CUSTOMER NOTICE OF PRODUCT/PROCESS CHANGE

Customer Name:	All Customers
CTS Part Number:	<hr/> 220AMA04R, 220AMB04R, 220AMC04R, 220AMA10R 220AMB10R, 220AMC10R, 220AMA16R, 220AMB16R 220AMC16R, 220ADA04, 220ADB04, 220ADC04, 220ADA10, 220ADB10, 220ADC10, 220ADA16, 220ADB16, 220ADC16 <hr/>

Description of Change: New design of housing and terminal change with new shape, print on the surface and increase of thickness

Table 1- Old Product Structure

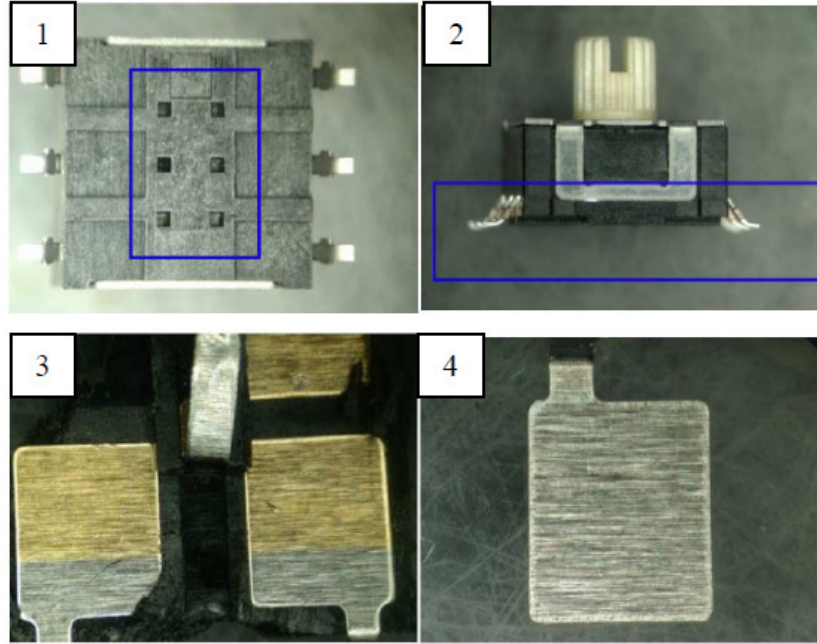
Reason for Change: In order to prevent the flux or epoxy from customer’s special soldering process will immersion through holes on the old design of housing to affect the switch contact function, we decide to the product structure enhancement to supply more reliable and robust product.

(1) 6 holes at the bottom for plastic injection purpose.

(2) Terminal thickness was 0.15mm.

(3) No V shape notch on the terminal.

(4) No print of mark on the back of terminals.

(1) Block the holes on the bottom of housing and add the No. of output, which will prevent the flux to intruding..

(2) Increase the terminal thickness from 0.15 to 0.25mm, which will avoid terminal deformation in the application.

(3) Add the V shaped notch at the start of terminal. The V shaped will obstruct the flux to move to contact area.

(4) Add the print of mark on the back of terminals. The print of mark will obstruct the flux to move to contact area.
